Mask integration at Point 8

HL-LHC integration meeting n50, 29 July 2016

F. Sanchez Galan on behalf of WP8

Proposition of mini TAXN integration

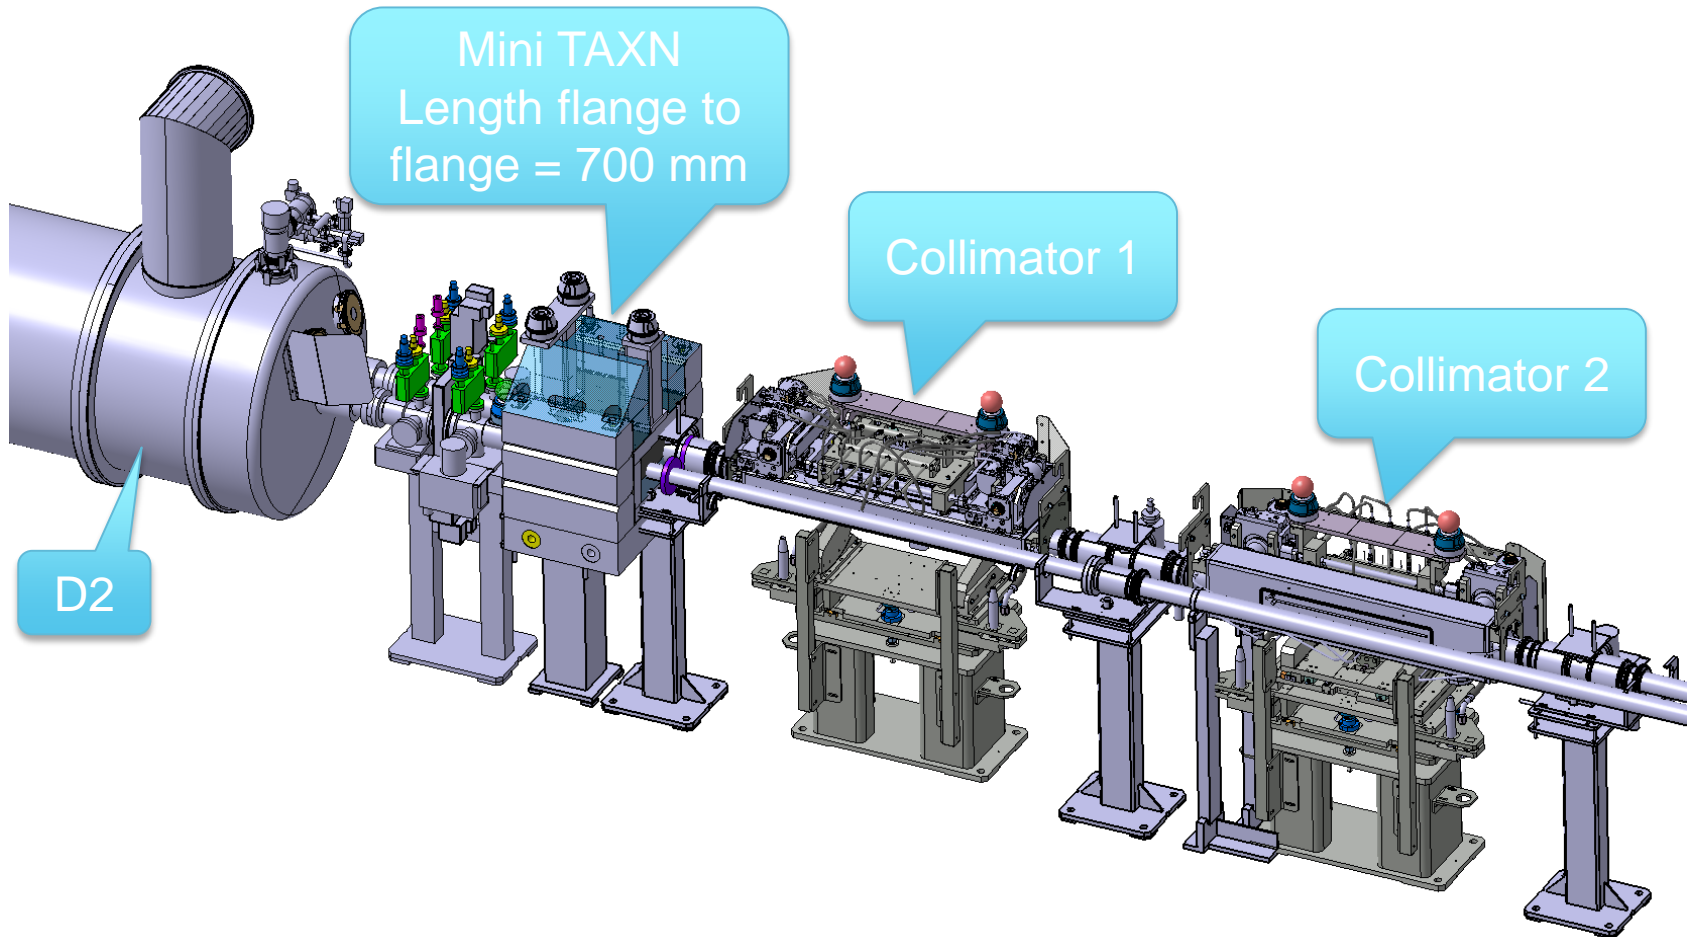
- Is the shielding enough ? (Needed alignment)
- Is the access to BPM ok from a RP view? (Needed alignment between collimator and mini-TAN)
- Do BPM and collimators require additional protection against debris?
- Are quick connectors required?
- Is it possible to displace the collimators & equipment up to Y-chamber flange?
- Would fit in the available space or would imply cutting the Y chamber sector? Any concern about ?

- Is the shielding enough ? (Needed alignment) →YES
- Is the access to BPM ok from a RP view? (Needed alignment between collimator and mini-TAN -->Dominated by D2
- Do BPM and collimators require additional protection against debris?→ No
- Are quick connectors required?
- Is it possible to displace the collimators & equipment up to Y-chamber flange?→ Yes
- Would fit in the available space or would imply cutting the Y chamber sector? Any concern about ?
- Radiation Interventions on BRAN
- LHCb scintillators
- Mini-TAN handling, quick connectors difficult.

NEW layout (option 1)

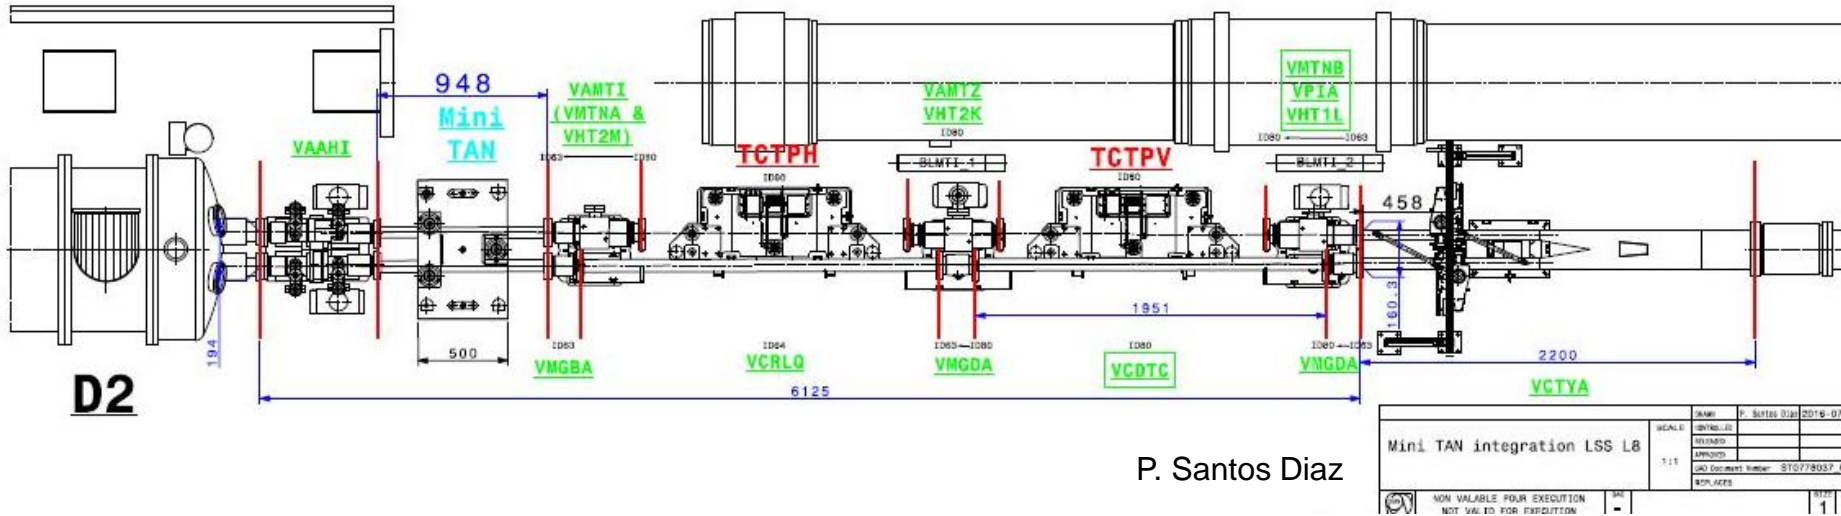
- Keep BPM's on its actual position
- Keep position of the Y-chamber

Actions required:

- Move collimators (TCTPH and TCTPV) ~700 mm
- Remove Vacuum module and Vacuum chamber → space gained: ≈ 675 mm.
- Cut Y-chamber.
- Rotate 180° vacuum support and update it.
